## **Las Posas Valley Groundwater Basin Technical Advisory Committee Special Meeting**

#### **2. Continued Discussion / Committee Consultation: Basin Optimization Yield Study Modeling Scenario Results**

**Email with TAC Clarifying Questions Regarding Basin Optimization Yield Study  
Model Scenario Results, August 7, 2025**

**Watermaster Committee Consultation on the Las Posas Valley Basin, Basin  
Optimization Yield Study Numerical Modeling Results, August 29, 2025**

## Principal Area of West Las Posas Managment Area In-Lieu Deliveries

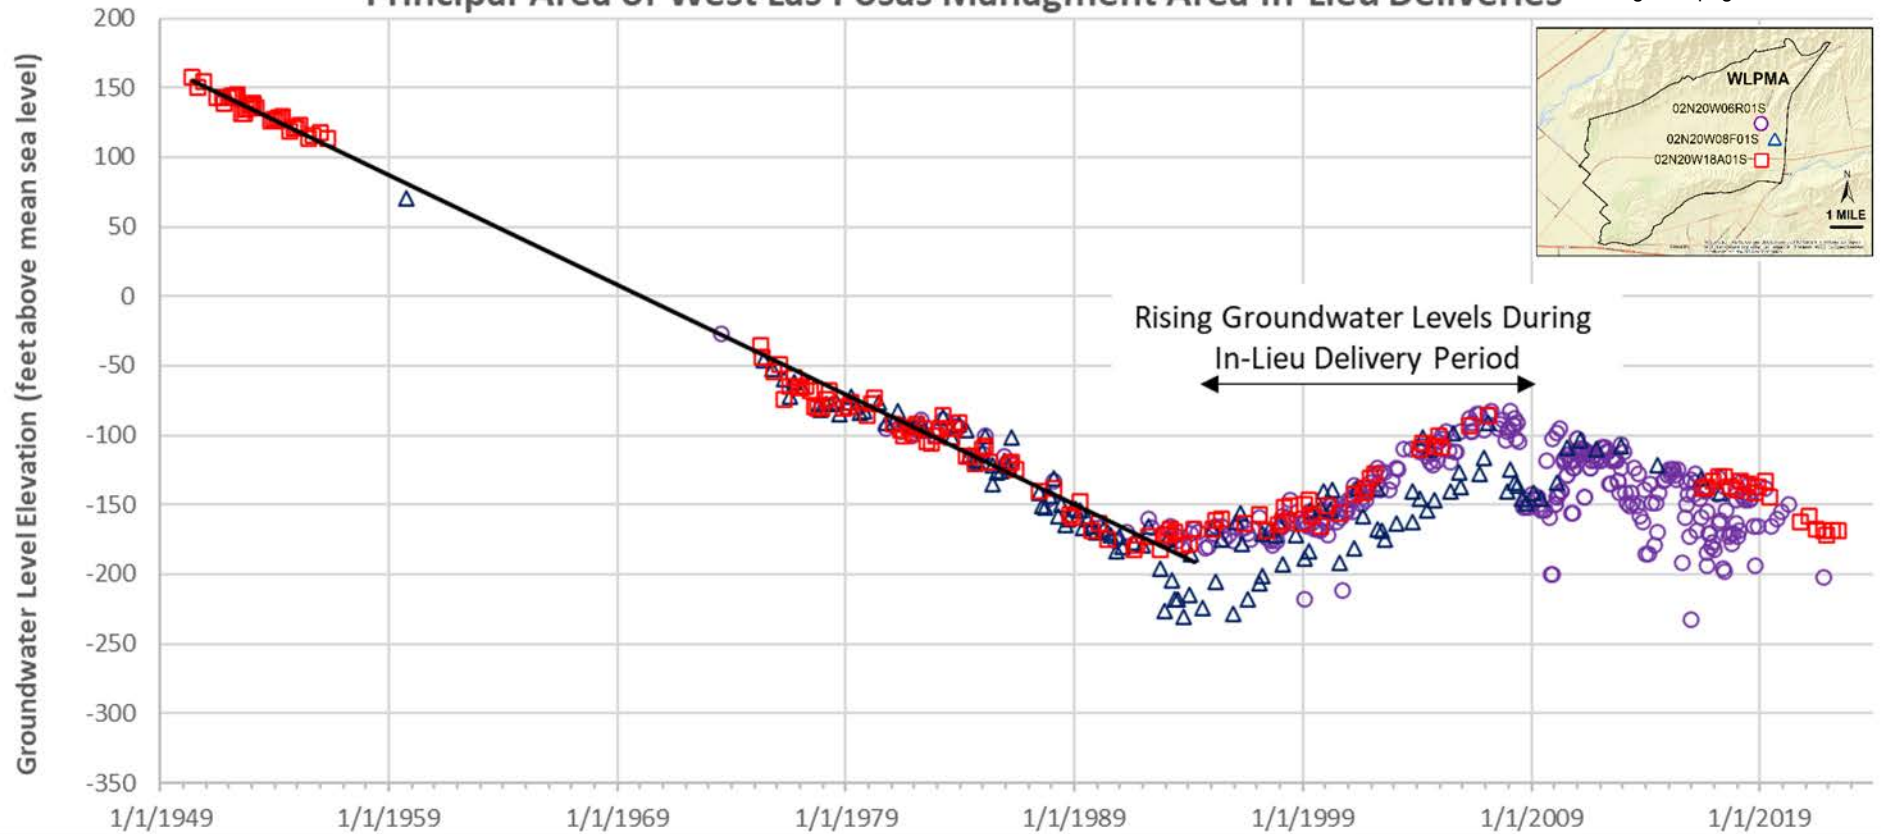
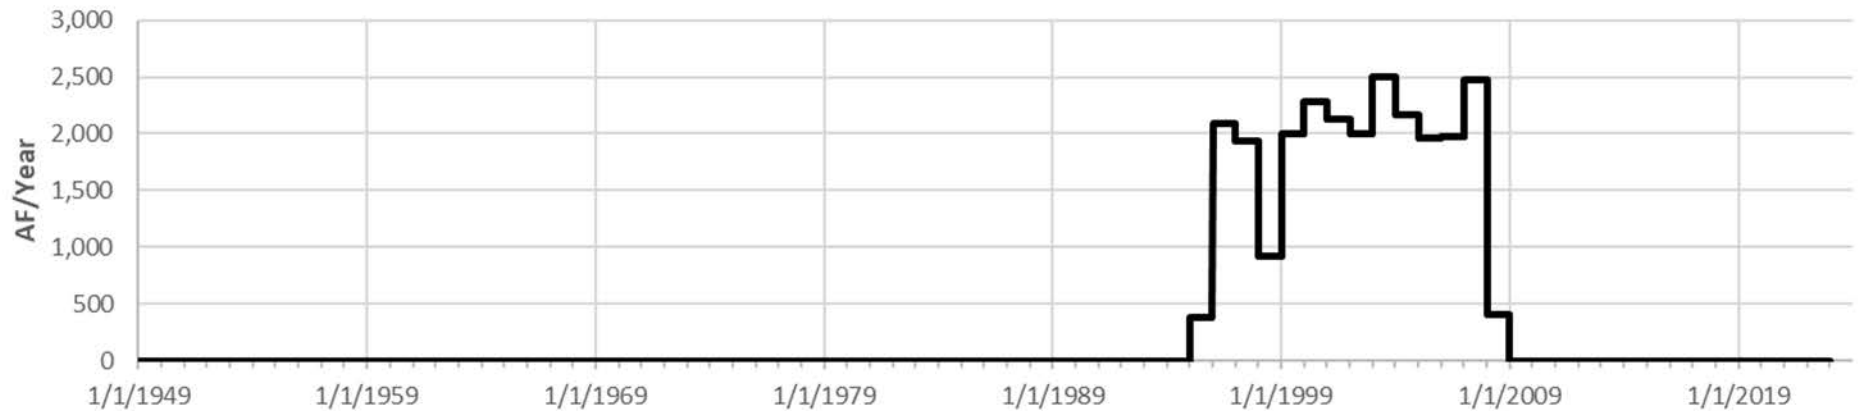
Mr. Bondy then showed the TAC a hydrograph of long-term groundwater levels with a period of decline followed by a period of recovery that corresponded with a historical in lieu delivery program. That historical in lieu was similar in volume to what is planned currently. Mr. Bondy indicated that despite the model results questions raised by the TAC, the historical data and operations should provide a level of comfort that the proposed project should have expected benefits. This graph is also included in Attachment 1.
